Application for Licence Amendment

Licence Number	L8666/2012/2
Licence Holder	Northern Star (Carosue Dam) Pty Ltd
ACN	116 649 122
Application Number	APP-0028046
Premises	<p>Mt Celia</p> <p>Legal description –</p> <p>Mining tenements M39/307, M39/740, L39/128, L39/130 and L39/134</p> <p>MENZIES WA 6436</p> <p>As defined by the Premises maps attached to the Revised Licence</p>
Date of Report	31 July 2025
Decision	Revised licence granted

Figure 1: Site layout, including Safari Bore Pit, Deep South Pit, and dewatering pipeline corridor

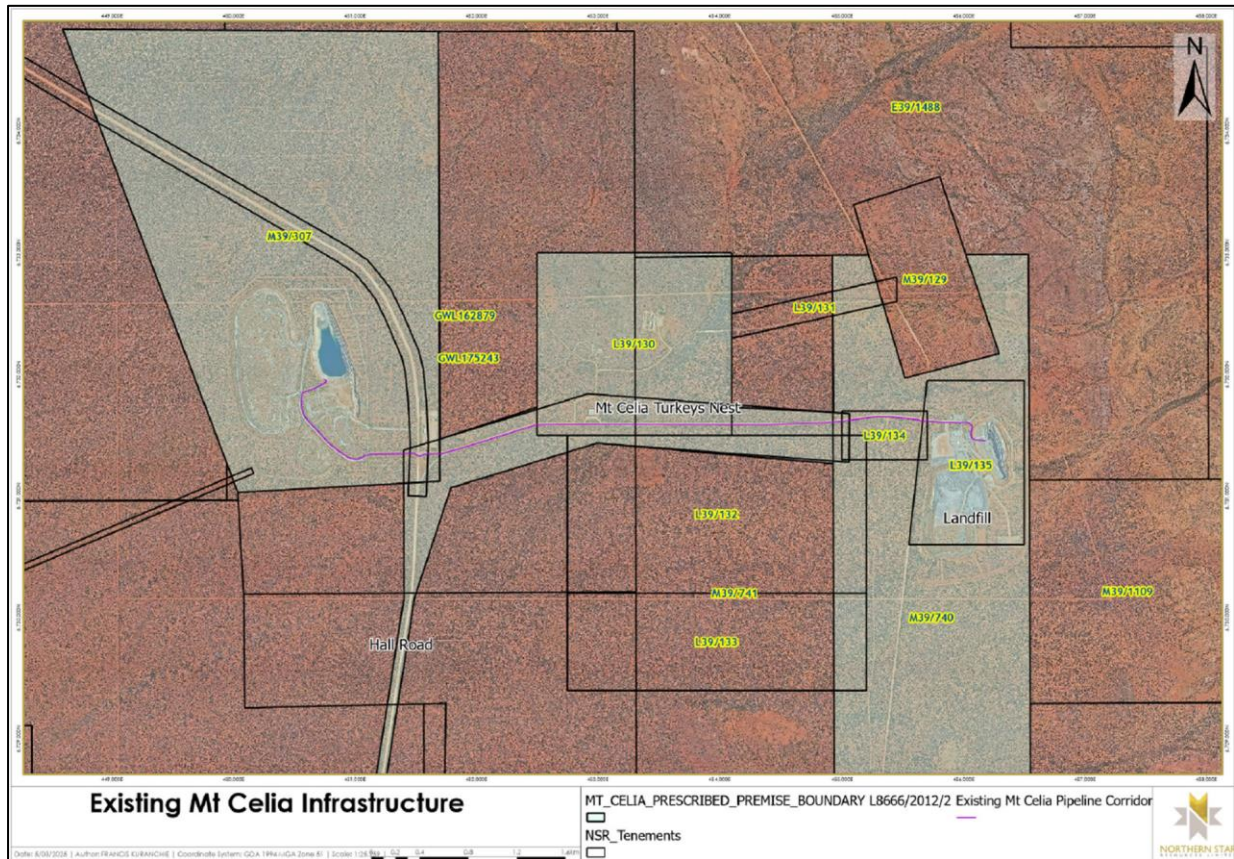
- Install a new DN355 pipeline within the existing 6.5 km pipeline corridor between Safari Bore and Deep South Pits (Figure 1), including pumping equipment, telemetry, flow meters (at both dewatering and discharge points), leak detection and cut-off devices;
- Construct a booster pump station comprising of a diesel generator (0.5 MW) and a 20 kL self-bunded fuel storage at the Safari Bore Pit; and
- Minor earthworks to the existing v-drain to accommodate the new pipeline.

The existing DN200 dewatering pipelines were determined to be unsuitable for the line pressure required. The existing Deep South turkeys nest will also be utilised to store mine dewater for dust suppression (Figure 1).

Figure 2: Predicted groundwater drawdown extent at Safari Bore Pit and groundwater mounding extent at Deep South Pit

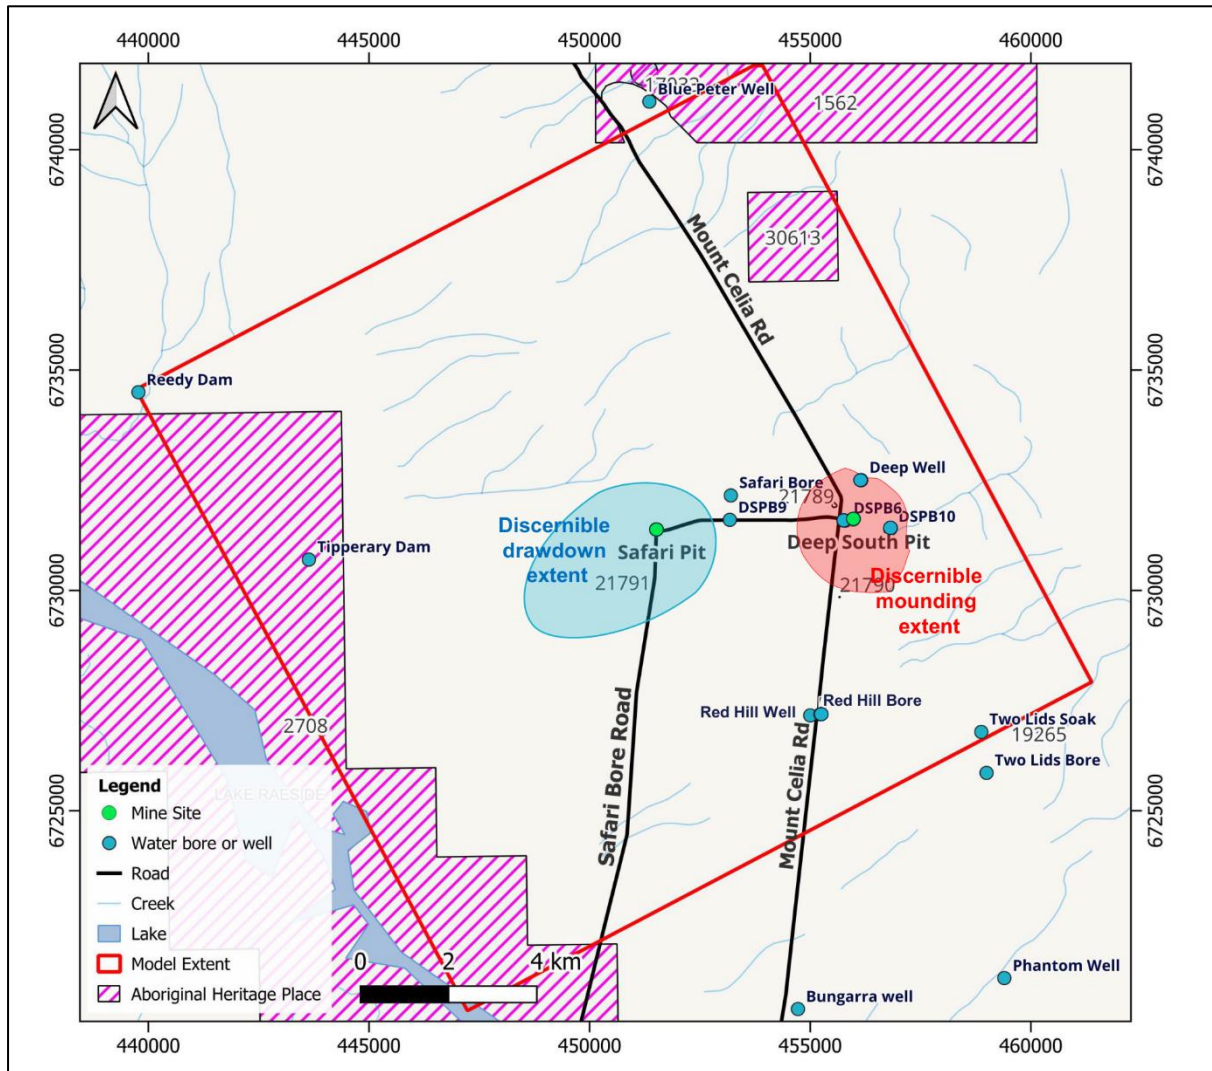
Numerical groundwater modelling undertaken by Pennington Scott (2025a) found that (Figure 2):

- A dewatering rate of around 140 L/s to 200 L/s would likely be necessary to dewater the Safari Bore Pit within six months, assuming ongoing groundwater inflow of 6 L/s into the pit.

- At the end of the dewatering program (i.e., once discharge of mine dewater has ceased), the Deep South Pit will contain a higher hydraulic gradient, resulting in seepage of pit water into the surrounding aquifer. This process will establish equilibrium conditions and may have an impact on surrounding groundwater levels and salinity up to a certain distance from the pit.

- Deep South Pit water level will reach approximately 90% equilibrium following a few months of discharge cessation, with full equilibrium being reached after approximately six years.

- The maximum extent of the groundwater mound is projected to extend up to 1,500 m to the south-west (hydraulically downgradient) and up to 600 m to the east (hydraulically upgradient).

- Solute transport modelling was undertaken using chloride as a proxy for salinity. Assuming a maximum concentration of 10,800 mg/L at the Deep South Pit lake and a concentration of 10 mg/L in the background groundwater environment, the model predicted the maximum potential extent of salinity to be up to 600 m to the south-west (hydraulically downgradient) and up to 300 m to the east (hydraulically upgradient).⁵

⁵ Based on report figure, it seems the range for 'impact' is from 250 mg/L onwards. Solute transport modelling relied solely on groundwater velocity, without accounting for other critical solute transport processes, such as hydrodynamics dispersion, diffusion, and potential chemical reactions.
